Planning Commission Meeting

March 12, 2024 6:00 PM

AGENDA

SHEET NUMBER
C2.00

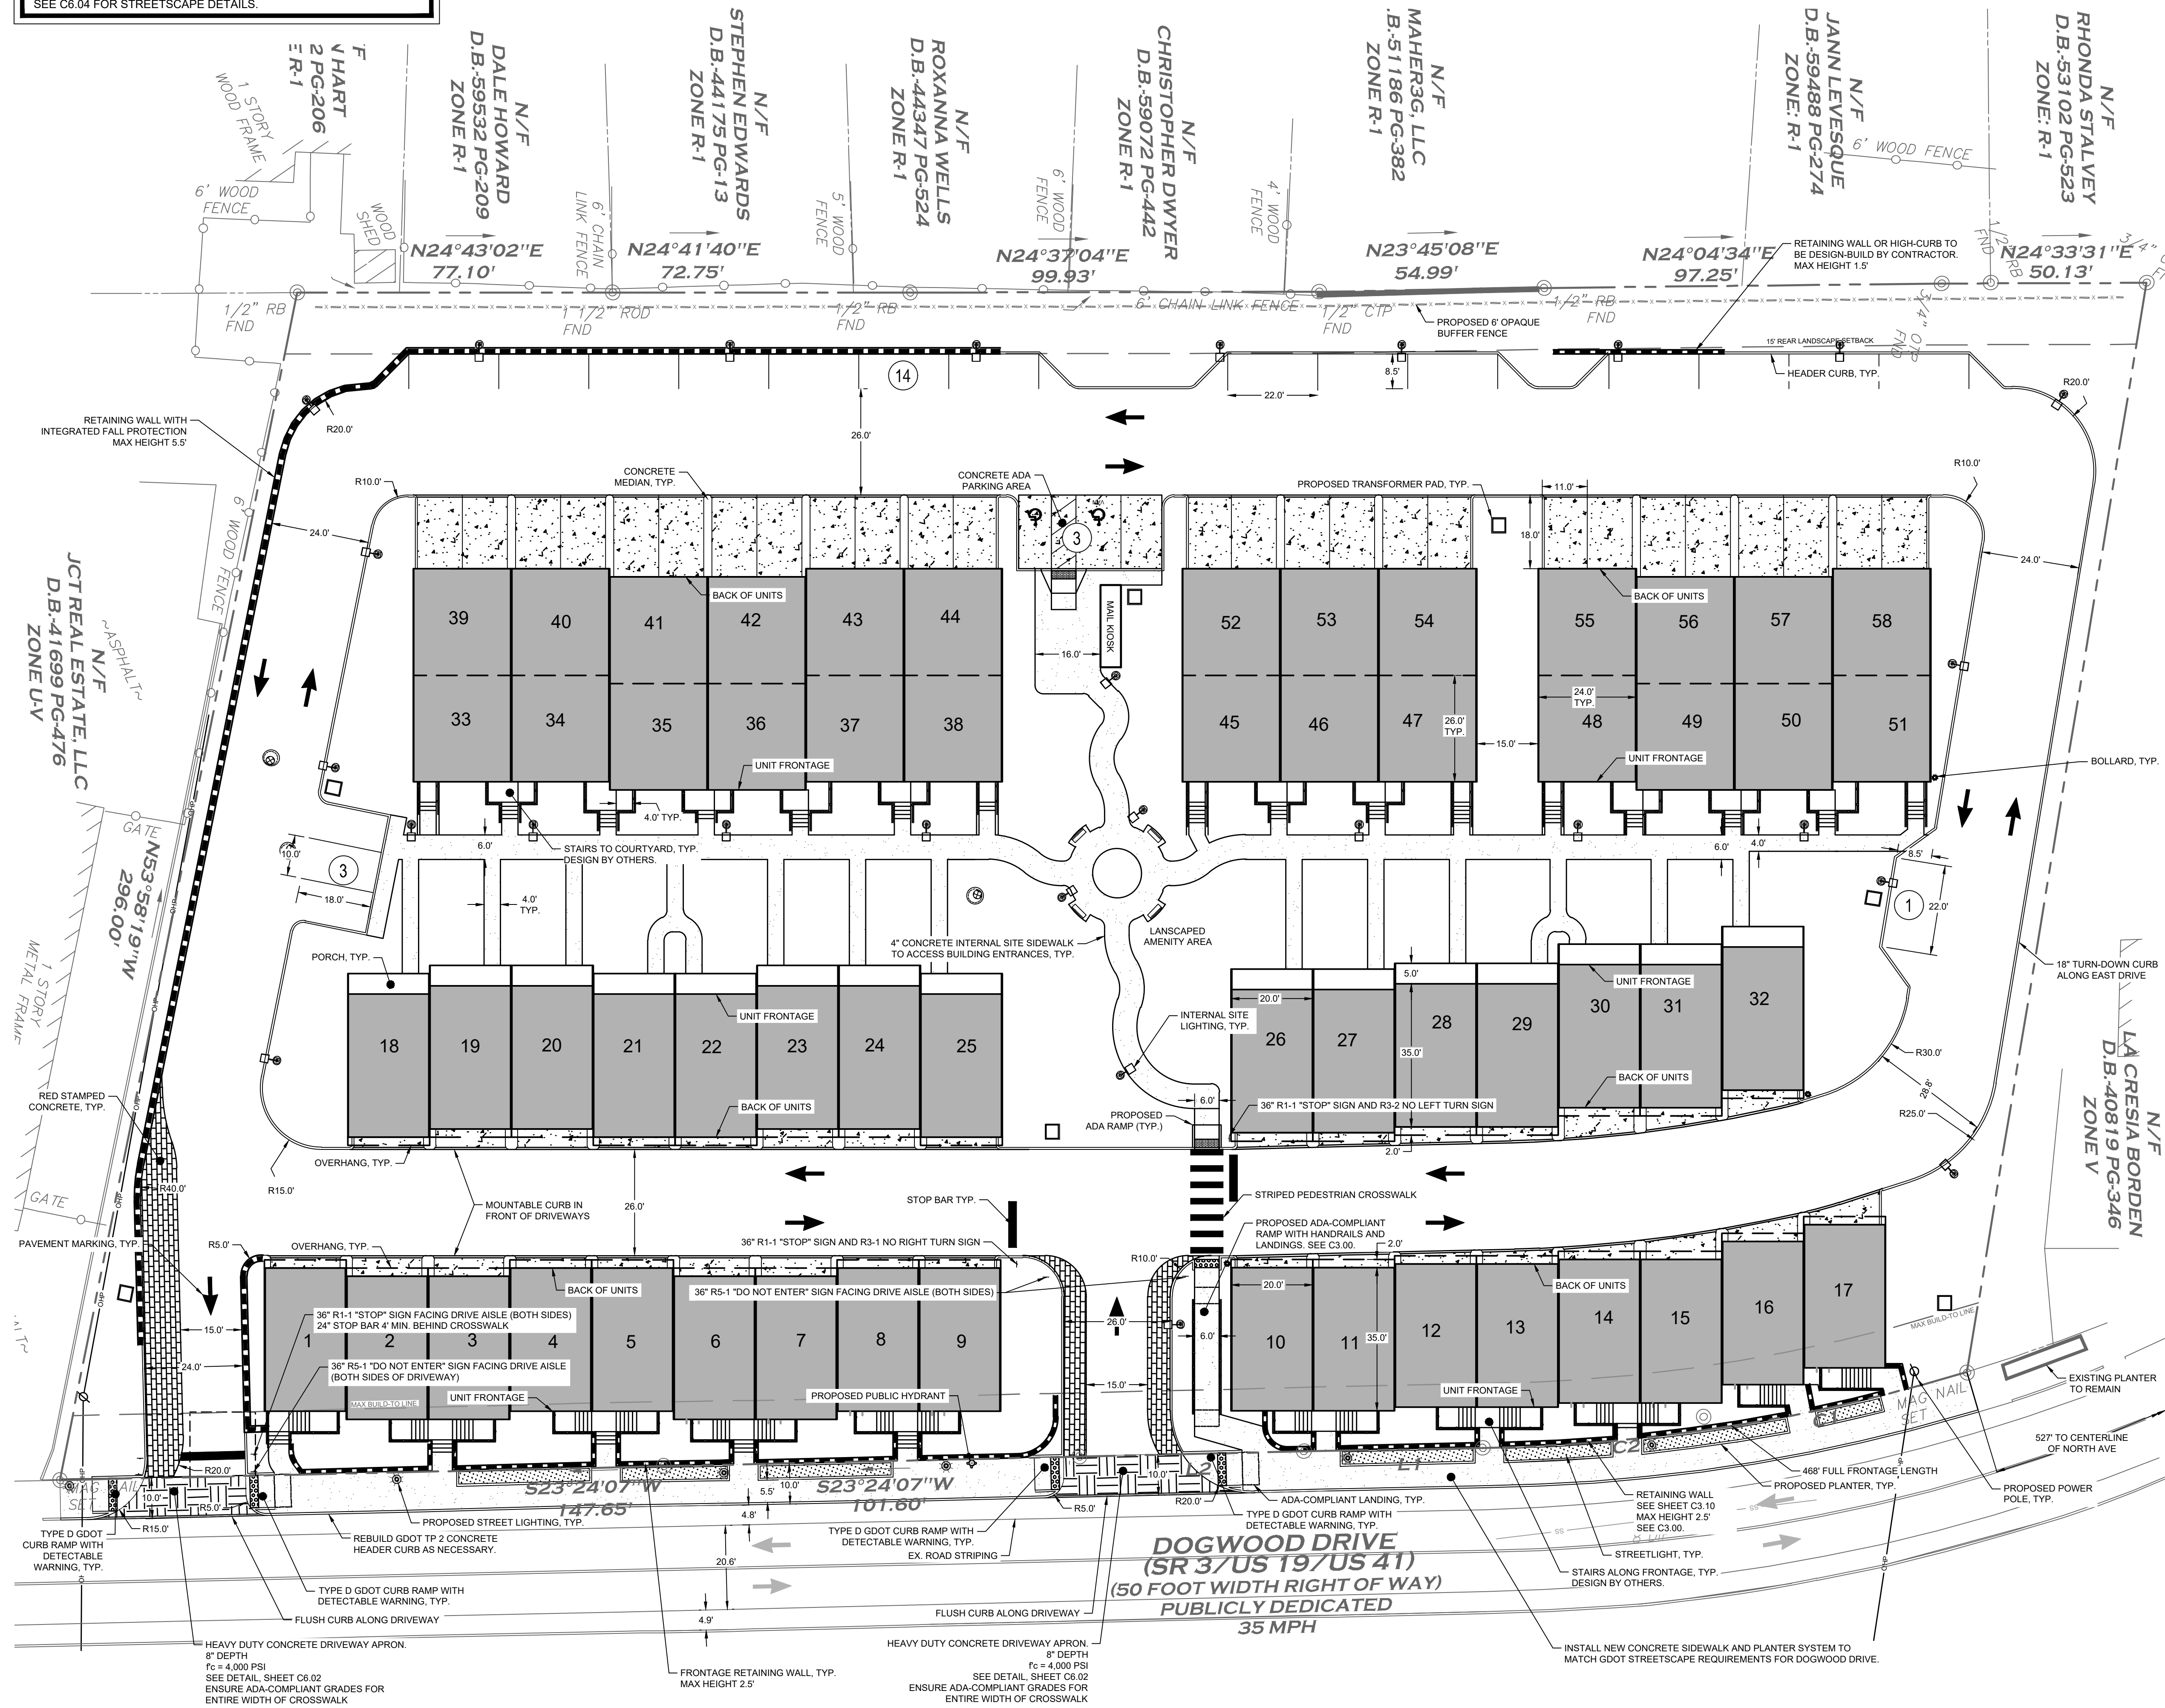
- Building height is measured from adjacent grade to highest roof point. Please provide full heights for compliance review.
- Timeline not provided.
- In some areas, with the planters, the sidewalk narrows to 5.5' instead of 10'. Plans indicate a new concrete sidewalk and planter systems will be installed to match city requirements for Dogwood Drive.
- The parking exceeds allowable per Code, but is desirable for visitors and supported by Staff. A variance was granted by Board of Appeals October 2022.
- Per the applicant (GDOT note on C2.00), GDOT granted a waiver for the driveway entrance.
